APPLICATION NO.	FILING DATE	FIRST NAMED INVENTOR	ATTORNEY DOCKET NO.	CONFIRMATION NO.
09/282,851	03/31/1999	CHANG-SOO PARK	678-252 (P8722)	9197

Office Action Summary

DETAILED ACTION

FIG. 2

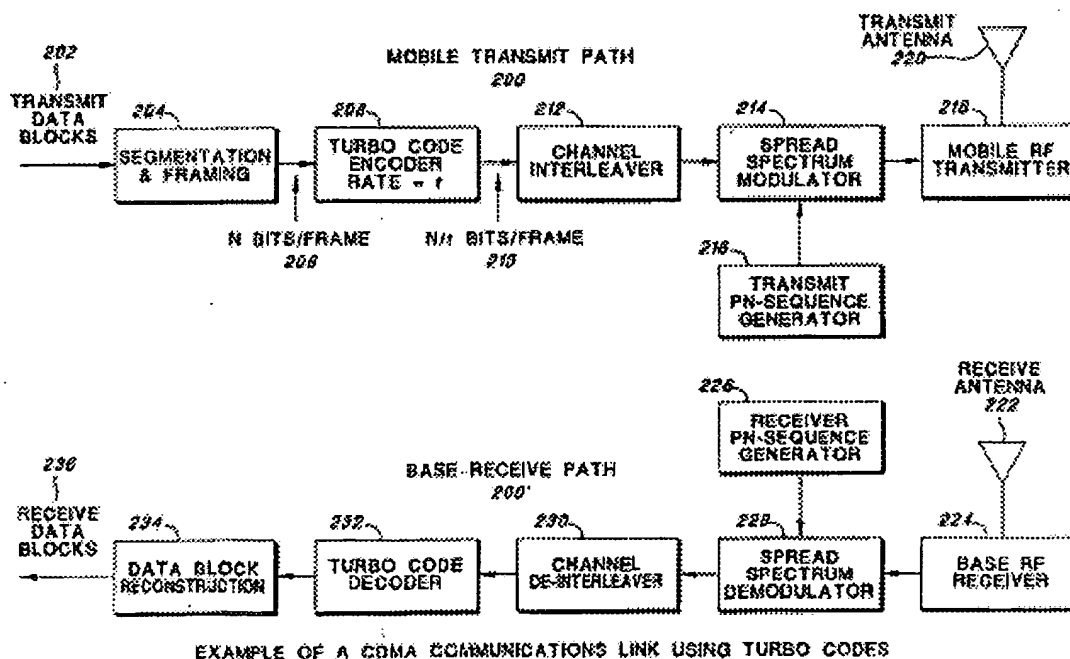
However such approach is well known. For example, Erroz et al., in an analogous art, discloses an information-processing algorithm wherein such techniques are described. {See Erroz et al., Id., Fig. 2 blocks 212 and 214.} Therefore, it would have been obvious to a person having ordinary skill in the art at the time the invention was made to modify the procedure of the Admitted prior art and Meidan et al. by including therein channel interleaving and multiplexing means, as taught by Erroz et al., because such modification would provide the procedure disclosed in the Admitted prior art and Meidan et al. with a technique whereby “*a channel 212 interleaver pseudo-randomizes code symbols*” for better burst error protection. {See Erroz et al., col. 6 line 28 et seq.}

As per Claim 102, Erroz et al. discloses the procedure for the claimed multiplexing means, including means for latency or permissible delay (col. 1 line 25 et seq.), block size or memory size adjustment (col. 2 line 10 et seq. and Fig. 2 blocks 204 and 234). {See Erroz et al., Fig. 2 and col. 14 line 12 et seq.}
